## DRAFT - FOR EXAMINER REVIEW ONLY!

Serial Number: 10/697,393

Title: DIGITAL TRANSMISSION SYSTEM USING NON-ORTHOGONAL MATRICES

#### **RESPONSE TO OFFICE ACTION**

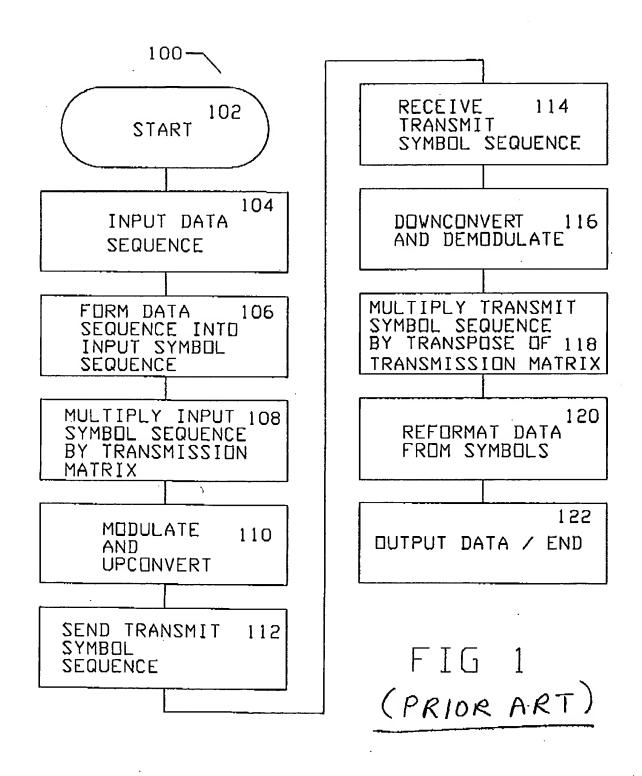
"(PRIOR ART)" is be added underneath "FIG 1" in a replacement sheet FIG 1.

# REPLACEMENT SHEET

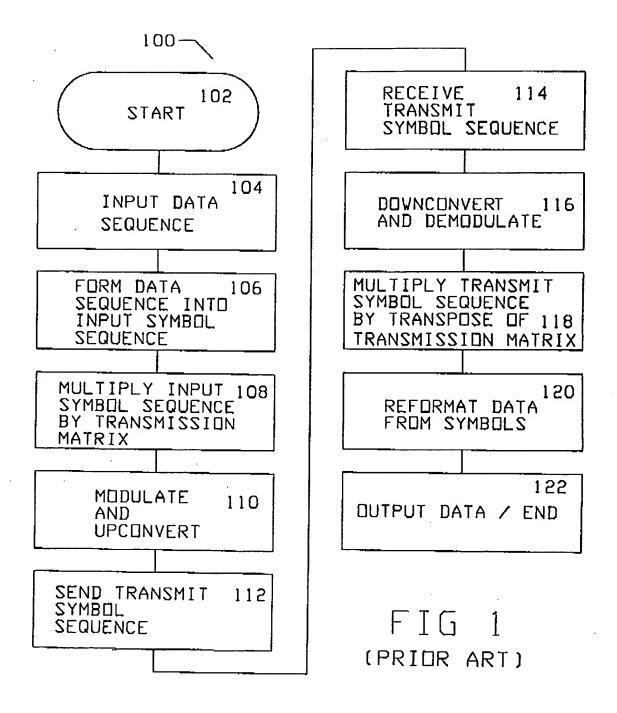
The first correction to the specification is an omission. The second and third corrections correct use of the word "row" when "column" was intended.

The word "ROW" has been replaced with "COLUMN" in a replacement sheet FIG 3. The error is evident when examining the numerical example of FIG 3.
